**City of Sherwood
PLANNING COMMISSION
Sherwood City Hall
22560 SW Pine Street
Sherwood, OR 97140
September 25, 2012 – 7PM**

Item A

Proposal: The applicant has requested site plan approval to construct between 190,530 and 192,532 square foot shopping center, based on the alternate options considered for proposed pads A and C, on approximately 19.82 acres of a 55.09 acre parcel of land. The request also includes a conditional use permit to allow outside storage and sales, and a separate request for a design modification to the right-of-way requirements for the extension of SW Century Blvd. to allow the sidewalk to be placed curb tight and street trees to be planted within tree wells. The parent parcel (55.09 acres) recently received preliminary subdivision (SUB 12-02) approval to divide the land into five individual lots and two tracts for future development consistent with the Sherwood Village PUD 95-1.

TRASH ENCLOSURE #4 SITE PLAN
3/32" = 1'-0"

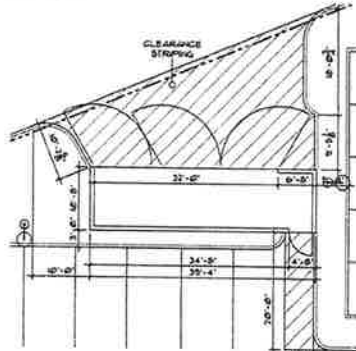
Pride Disposal Co.: Kristin Leichner of Pride Disposal, provided staff with comments that indicates that Pride disposal has some concerns with two of the six proposed enclosure locations. She added that it would be possible to redesign them in order to be serviceable. Ms. Leichner's comments are attached to this report as Exhibit H.

Good morning Kristin, attached is a revised Sheet A1.2 with dimensions on the trash enclosures. Also, I made up a second sheet, which shows both an expanded area at the 3-bay enclosure, and an enlarged plan at the anchor's disposal area.

Exhibit 1. Northbound Add Lane on Highway 99W (Image Source: Google Earth)

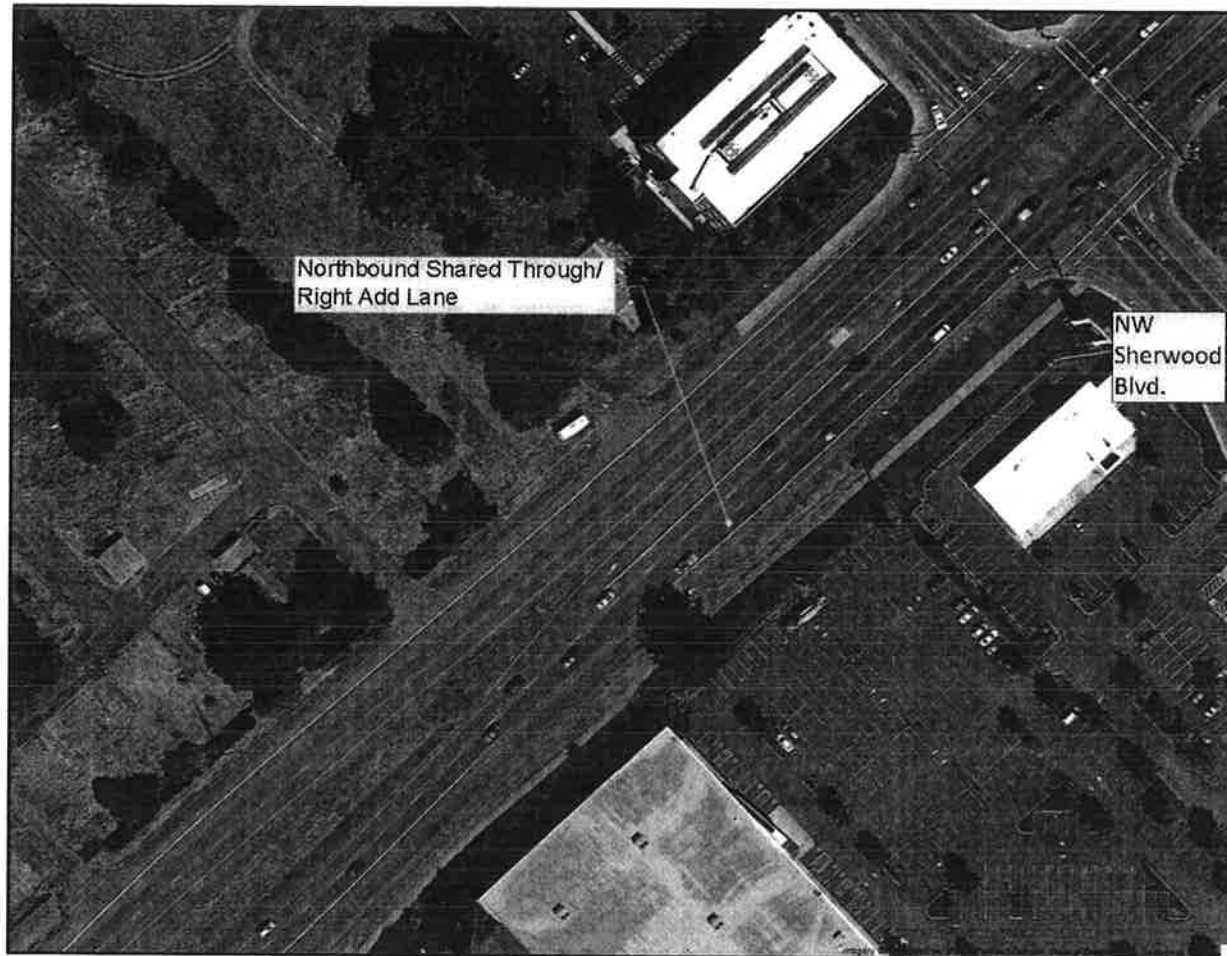
- 1. 99W/SW Sherwood Blvd Intersection: The applicant shall lengthen the storage distance on the northbound right turn lane to 625 ft with the associated deceleration distance.*

While ODOT's letter recommends extending the Highway 99W northbound right-turn lane storage distance to 625 feet, there is not a dedicate right-turn lane today. As shown in Exhibit 1 below, there is an add lane south of SW Sherwood Boulevard, where the Highway 99W northbound lanes widen from a northbound through lane and shared through/right lane to two northbound through lanes and a shared through/right lane. As an add lane, through traffic tends to use the shared lane when storage is available but only up to the available storage – through vehicles otherwise remain in the two other through lanes.

We separately analyzed intersection operations and queuing at the 99W/SW Sherwood Boulevard-SW Edy Road intersection assuming two northbound through lanes and a dedicated right-turn lane. The results of the analysis indicate that a *separate* northbound right-turn lane would operate with a 95th percentile queue of approximately 250 feet; 50 feet short of the 300 feet of available storage. Based on this analysis, there is not a need for additional queue storage if the lane is striped as a northbound right-turn only lane as suggested by the ODOT letter.
